LAZY DOG RESTAURANT

VILLAGE ON THE PARKWAY

We have created Sheet C5.0A Utility Plan & Sheet C5.4 Utility Details to show the new 6" sanitary sewer lateral connection to the existing 8" sanitary sewer main in the drive aisle south of the project site. Based upon comments from the City, we were able to obtain a more recent as-built of the existing 8" PVC sewer line, entitled "5100 Belt Line Rd #500 (Plan Review A-2-Occ_II-B Lazy Dog) 11-10-14.pdf."

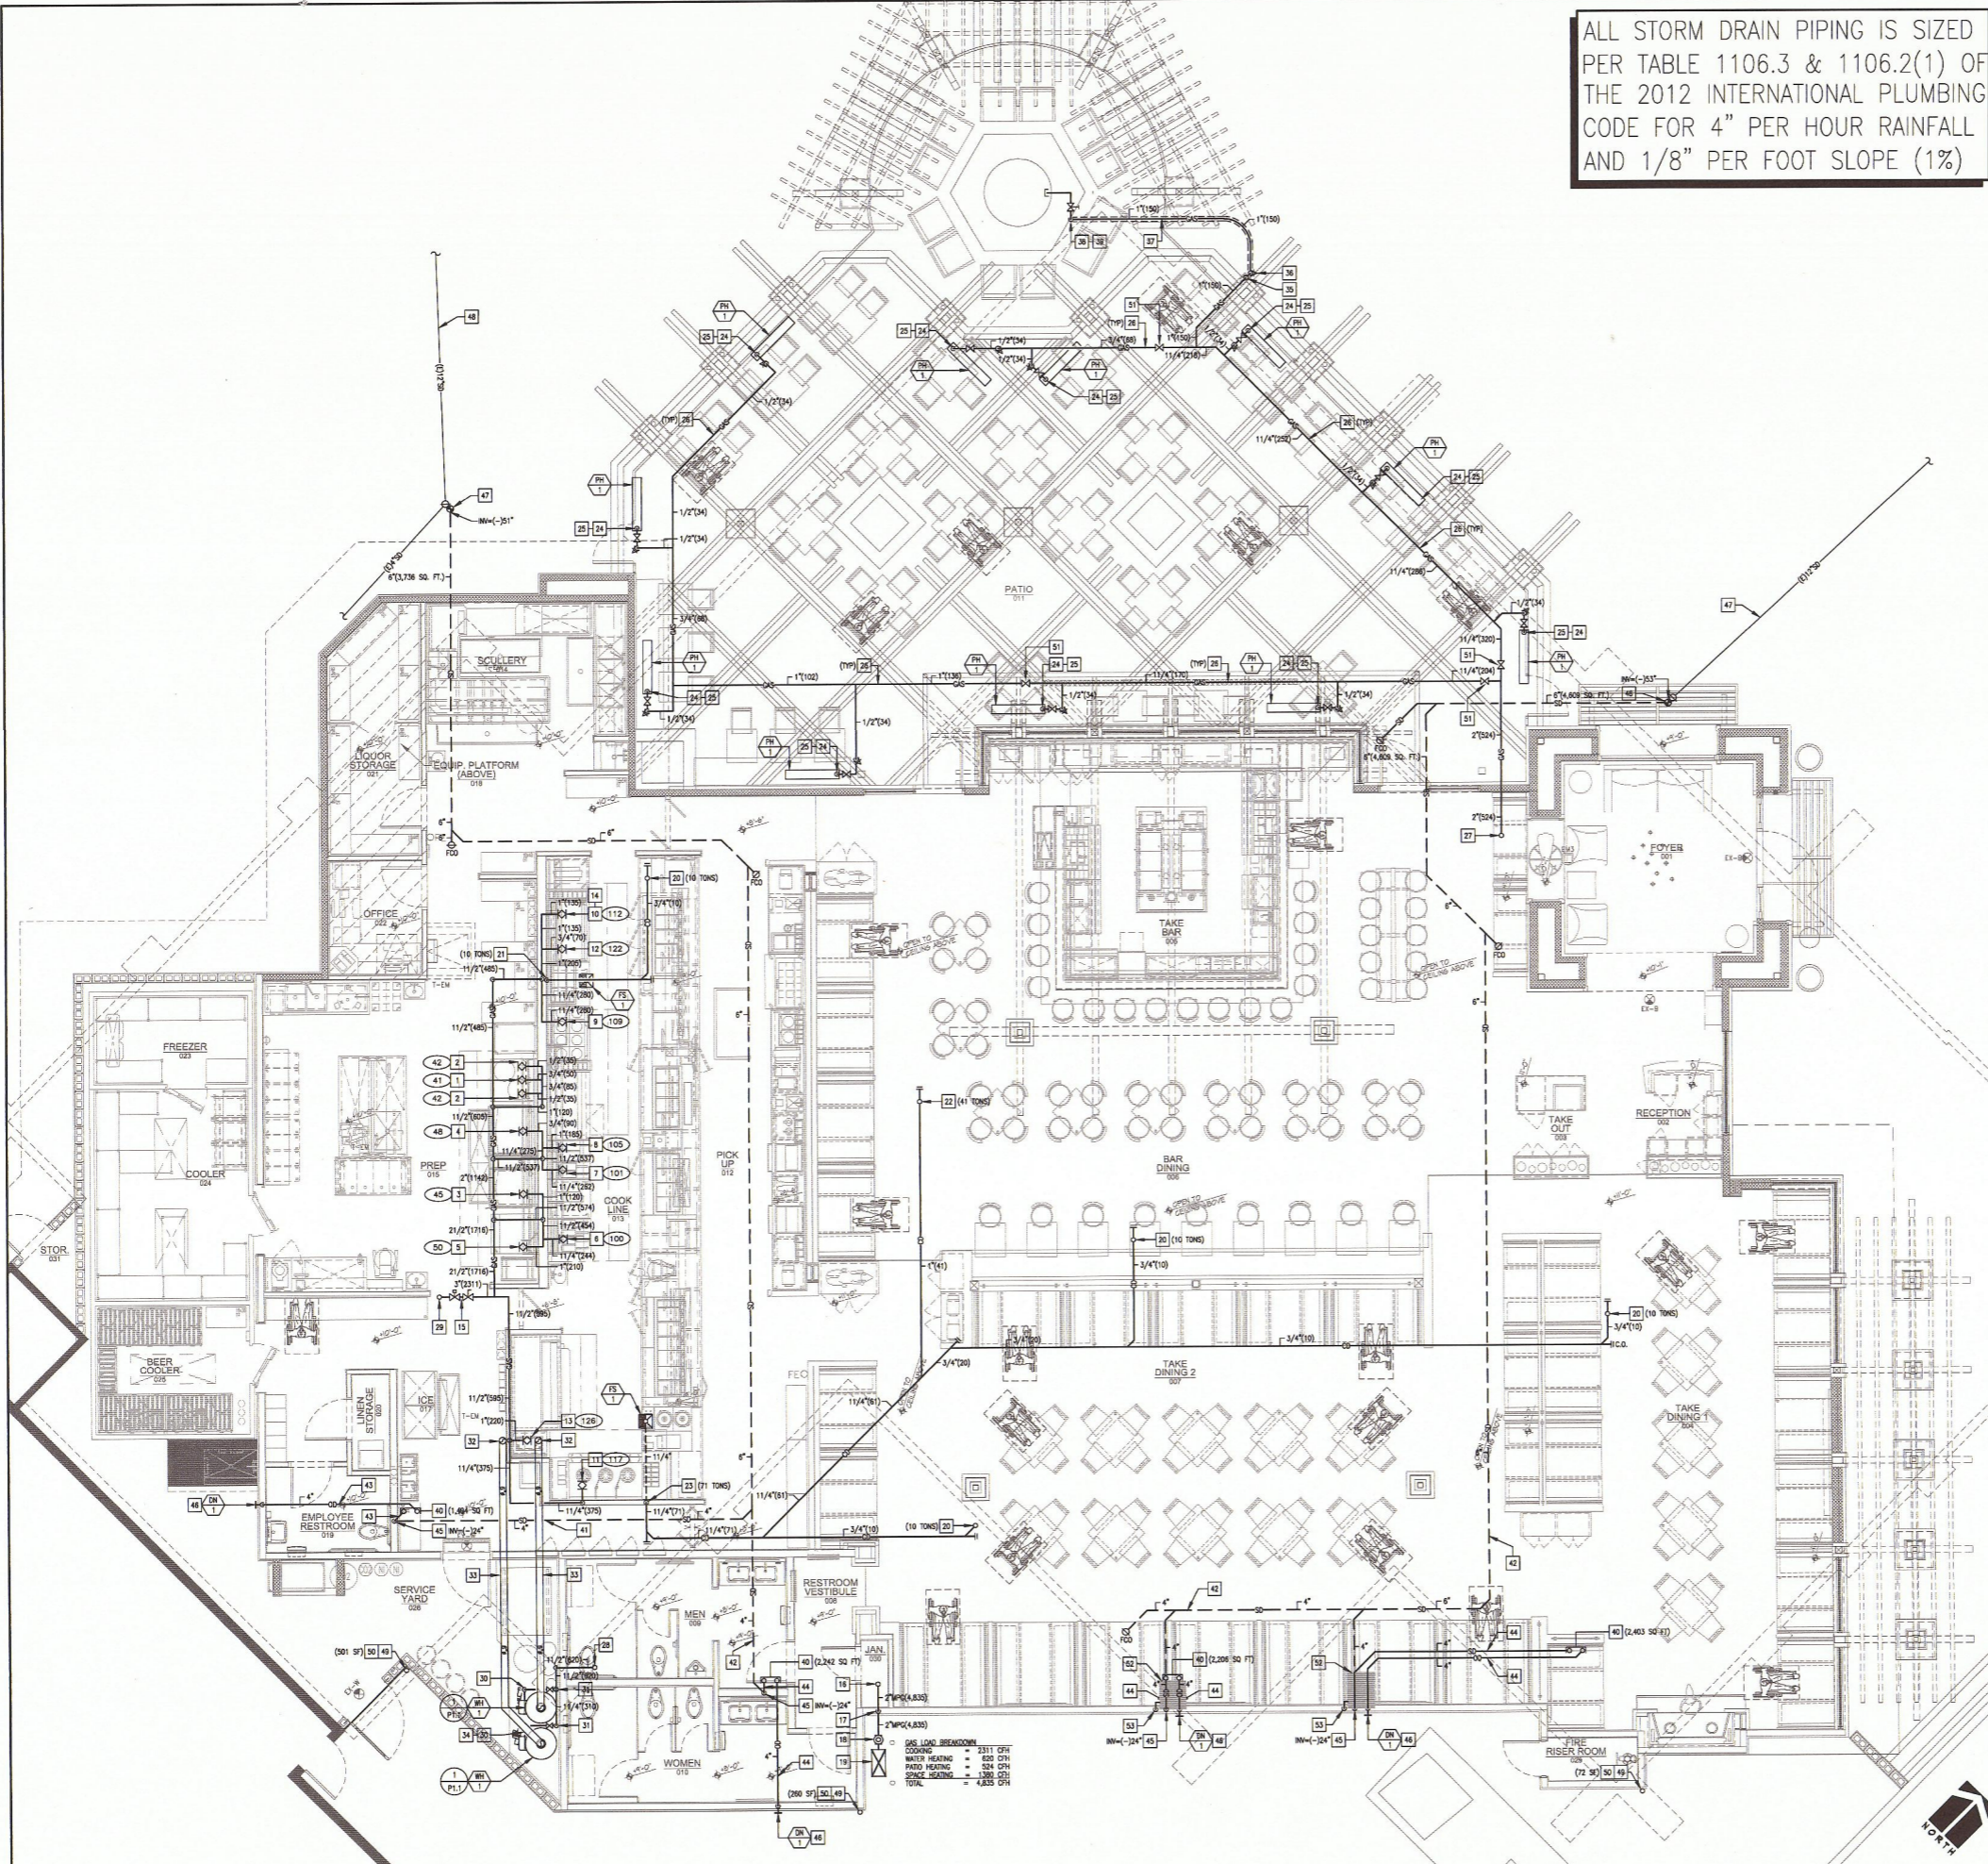
COMMENT FROM THE FIRE DEPARTMENT:
RELOCATE FIRE SPRINKLER AND FIRE ALARM DEVICES AS NECESSARY TO PROVIDE PROPER COVERAGE.

SHEET NUMBER:
C5.0A

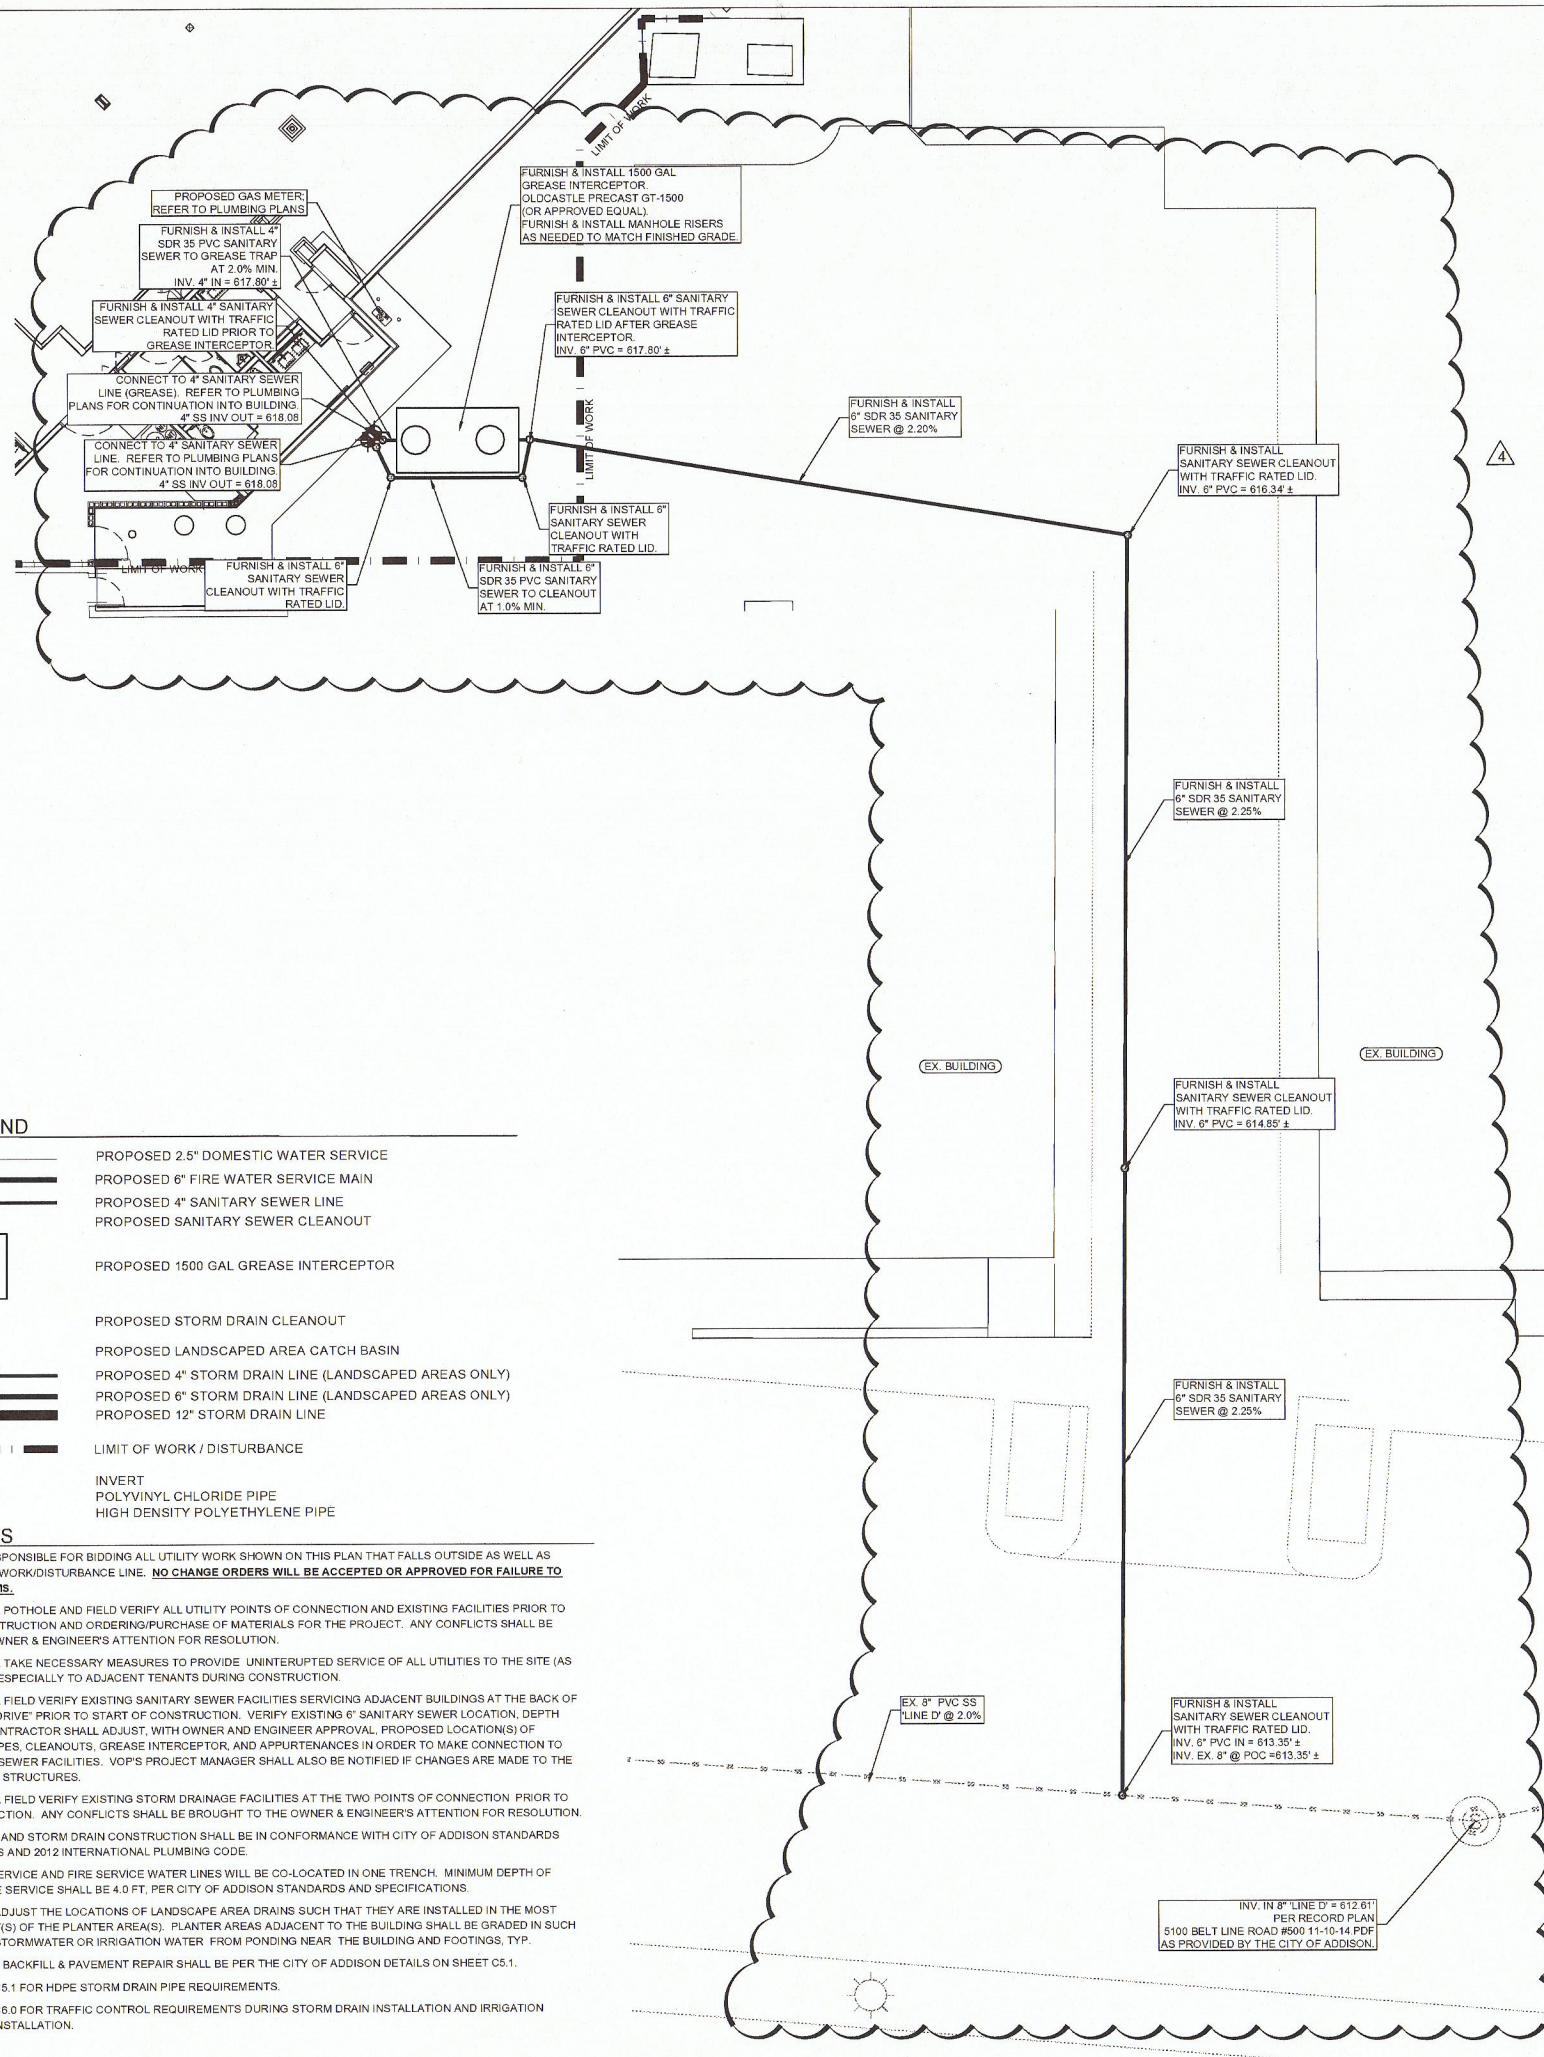
1. Inverts provided into and out of the new Lazy Dog grease interceptor. Please note the manholes on the grease interceptor shall be fitted with risers, per manufacturer recommendations, to bring the manhole access to match finished grade.

2. Added approximately 197 linear feet of 6" SDR 35 sanitary sewer line at approximately 2.25% slope to connect to the existing 8" sanitary sewer line.

4. Added 3 new sanitary sewer cleanouts with traffic rated lids. Sanitary sewer cleanouts shall be set to match finished grade.
5. Added 4 details provided by the City of Addison, for utility trenching and repair, to new sheet C5.4.
